THE CITY OF KEY WEST PLANNING BOARD Staff Report

Agenda Item: Variance- 411 Louisa Street (RE#00029190-000000) - A request for a

Request: The applicant is adding a second story addition and remodeling the

Location: 411 Louisa Street (RE# 00029190-000000)

Proposed Site Plans, submitted by the applicant

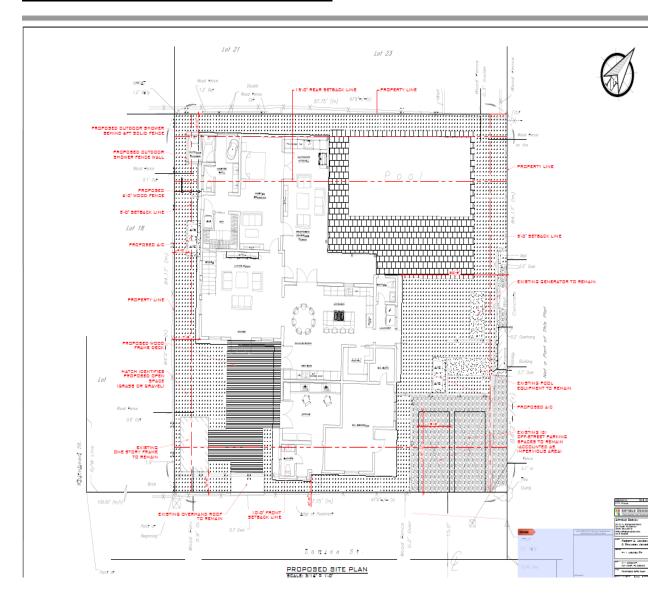
The applicant is requesting 64% impervious surface. The code requires no more than 60%.

The applicant is requesting 30% open space. The code requires no less than 35%.

The applicant is requesting 2.6" front setback. The code requires 10'.

The applicant is requesting 4' left side setback. The code requires 5'.

The applicant is requesting 4' rear setback. The code requires 20'.

The variance requested is not the minimum variance that will make possible the reasonable use of the land, building, or structure. However, the proposed vertical addition above existing habitable space provides for a 3-foot setback to the rear property line from the roof overhang which currently has a 0-foot setback. Other aspects are improving from the current situation, such as open space requirement and impervious surface ratio.

The Variance request for exceeding the allowed front setback, left side yard setback, rear yard setback, maximum impervious surface ratio and open space coverage at a proposed residence does not comply with the evaluation criteria, although the proposed construction would be a modest improvement with respect to open space, impervious surface and building coverage. Given the applicant's proposed project does not meet with all review criteria, the Planning Department recommends **DENIAL**.
